PEUGEOT/CITROËN THERMOSTAT REDESIGN TO OVERCOME OVERHEATING ISSUES

Issue Date: 23/09/19 Issue Number: COTB0024F

APPLICATION : Citroën C4, DS3, DS4, DS5, Peugeot 207, 208, 308, 3008, 5008, RCZ

APPLICABLE REFERENCES : FTK100 / FTK486

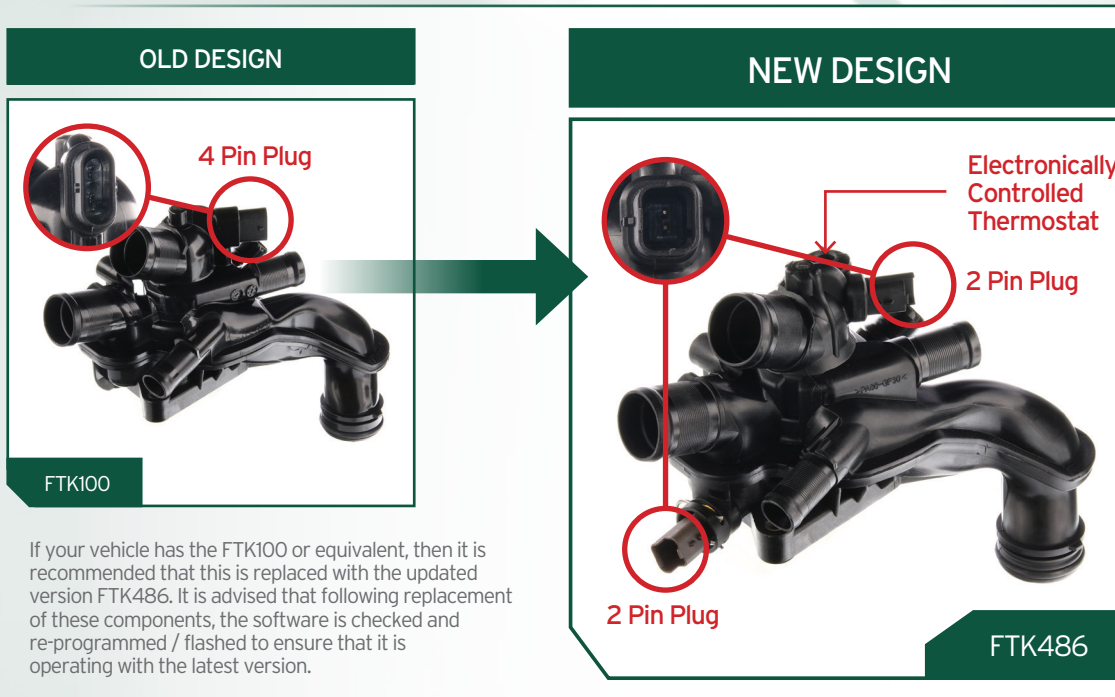
Due to an increase in overheating issues & symptoms such as an erratic temperature gauge, erratic running, radiator fan run-on, or poor heater function in the above vehicles, the O.E.M. have modified the design of the Thermostat housing. Following the O.E. specification, we have replaced the old design FTK100 with the new latest design FTK486. The latest design benefits from an electronically controlled thermostat, a reinforced structure, and a new configuration of sensors.

We have highlighted the key differences below so that you are clear that the latest part, although visually different to what may be on the vehicle, is in fact the correct product.

The modified version has two 2 Pin connectors instead of the one original 4 Pin connector, therefore, a new cable may also be required to carry out the modification.

New Cable: FTS3091 - Thermostat Wiring Harness
